PARKDALE NORTH
PD AMENDMENT AND PRELIMINARY PLAT

MAY - 2025

WHAT WE HEARD

ANTICIPATED SCHOOL SITE PLAN

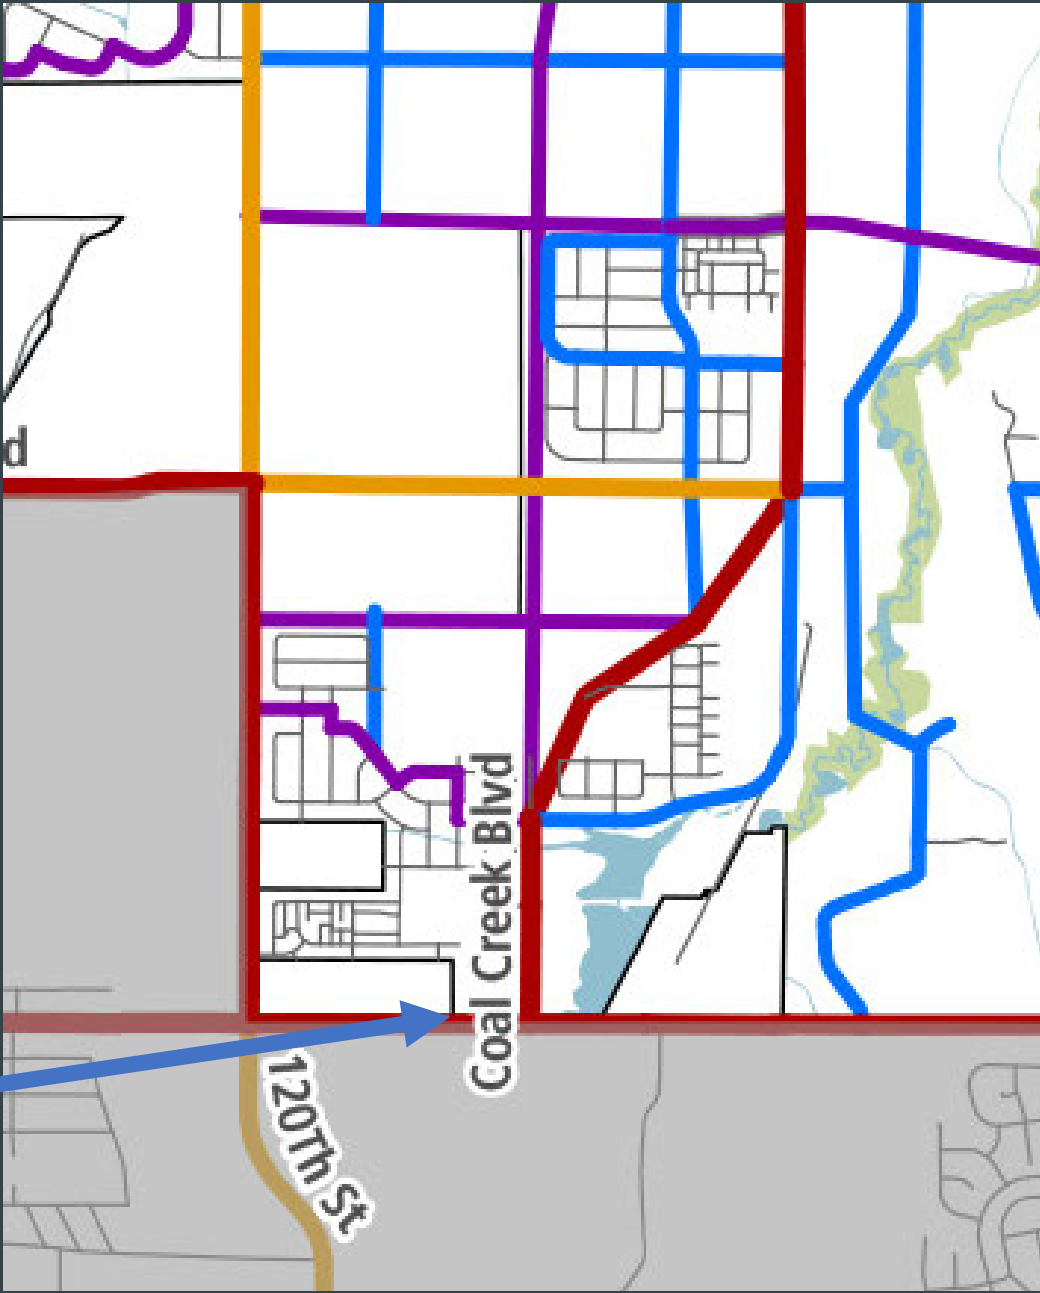
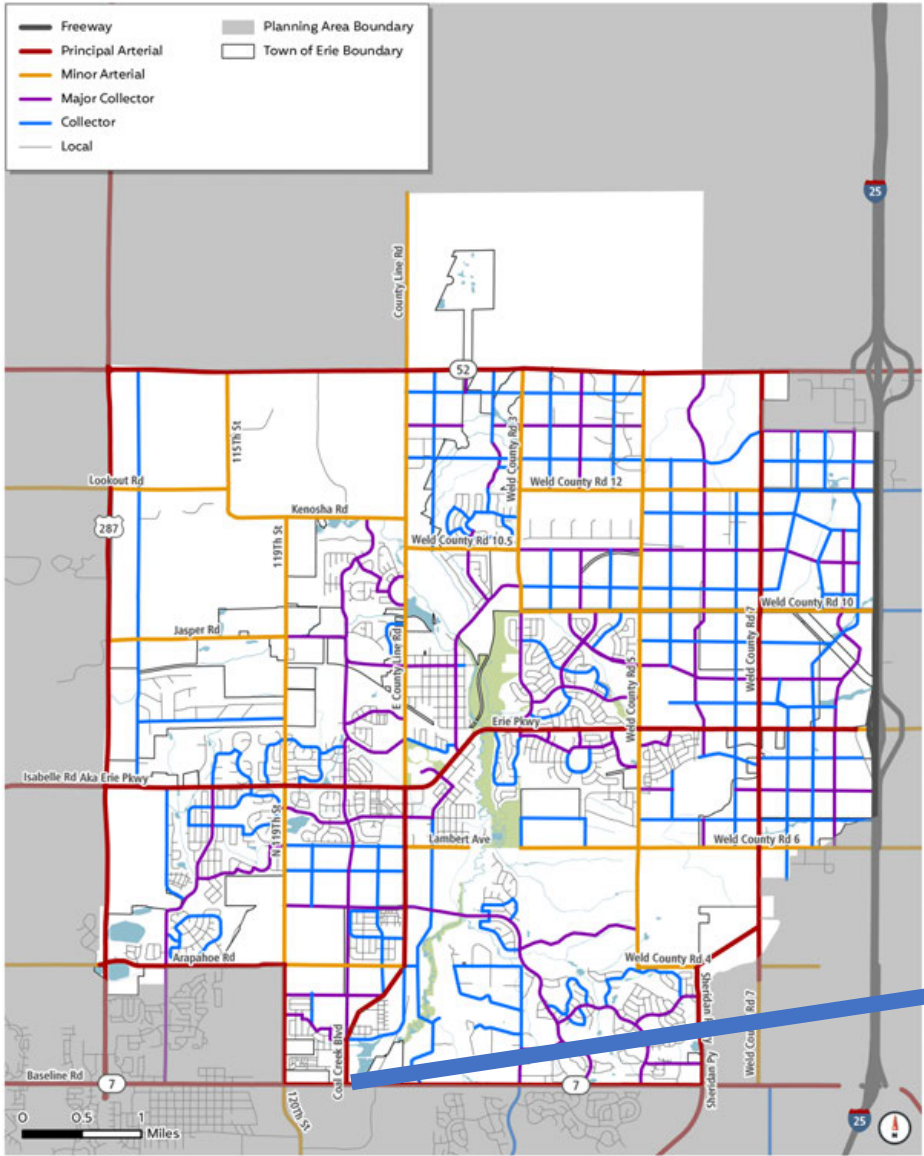
- Questions related to School site location, verify that the school site location would not impact the flow of traffic on the Future Coal Creek Boulevard.
- Provide more uses in the parks that include activities for more than just young children.
- Will there be enough room on the lots to plant trees and have a useable rear yard.
- Discussion related to providing cash towards the Compass Neighborhood Park in lieu of having an additional Neighborhood Park in Parkdale.

Fields can be used outside of School use times in coordination with the School District.

Anticipated School Zone, not on Coal Creek Boulevard

General Note, no driveways access the "School Zone" which allows better traffic flow for the school.

No School Access to Coal Creek Boulevard

- 4 LANES FROM VISTA PARKWAY TO HWY 7
- MODERN TWO-LANE ROUNDABOUT
- TRAFFIC SIGNALS CAN BE TIMED TO PRIORITIZE NORTH SOUTH TRAFFIC
- NO SCHOOL ZONE RECOMMENDED
- TWO GRADE SEPERATED CROSSINGS
